AMENDMENT OF SOLICITATION/MODIFICATION OF CONTRACT			1. CONTRACT ID CODE	PAGE OF PAGES	
			J	1	3
2. AMENDMENT/MODIFICATION NO. 0003	3. EFFECTIVE DATE 28-Jun-2007	4. REQUISITION/PURCHASE REQ. NO.		5. PROJECT NO.(If applicable)

14. DESCRIPTION OF AMENDMENT/MODIFICATION (Organized by UCF section headings, including solicitation/contract subject matter where feasible.)  The above numbered solicitation for Westbank and Vicinity, New Orleans, LA, Hurricane Protection Project, Lake Cataouatche Levee Enlargement, Lake Cataouatche Pump Station to Segnette State Park, Jefferson Parish, LA, is amended as shown on the attached pages.  PROPOSAL DUE DATE: THE PROPOSAL DUE DATE OF 10 JULY 2007, 2:00 PM LOCAL TIME, NEW ORLEANS, LA, REMAINS UNCHANGED.					
Except as provided herein, all terms and conditions of the document referenced in Item 9A or 10A, as heretofore changed, remains unchanged and in full force and effect.					
15A. NAME AND TITLE OF SIGNER (Type or print)			16A. NAME AND TITLE OF CONTRACTING OFFICER (Type or print)		
			TEL: _____ EMAIL: _____		
15B. CONTRACTOR/OFFEROR  _____ (Signature of person authorized to sign)	15C. DATE SIGNED	16B. UNITED STATES OF AMERICA  BY _____ (Signatu

**LEVEE STATION MARKER DETAIL**

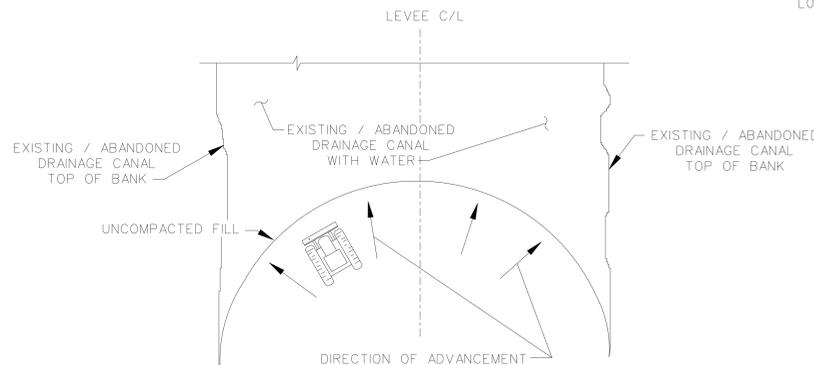
1. Page 7, paragraph 3.3. In the first line, change “6 inches” to “9 inches”.
2. Page 8, paragraph 3.6. Delete this paragraph in its entirety and substitute the following therefore.

Delete Sheet Identification Number 9 and replace with the attached revised Sheet Identification Number 9 therefore.

“3.6 LEVEE MARKER PADS

3.6.1 General

Levee marker pads includes the construction of the levee marker pad as shown on the drawing and the installation of the levee marker pad sign.

3.6.2 Levee Marker Pad

The levee marker pads shall be constructed with 7-inches of surfacing (loose measurement). Placement shall not commence until after all earthwork phases of the levee construction, (including fertilizing, seeding and mulching), have been completed.

### 3.6.3 Levee Marker Signs

Twenty levee marker signs are Government furnished materials. The signs are constructed of a 5 foot long typical u-frame post and a numbered green reflective sign. The installation of the signs requires pushing the sign post into the levee marker pad as shown on the drawings. Locate the bottom of the green sign as shown on the between 2 ½ and 3 feet above the levee marker pad surface.”
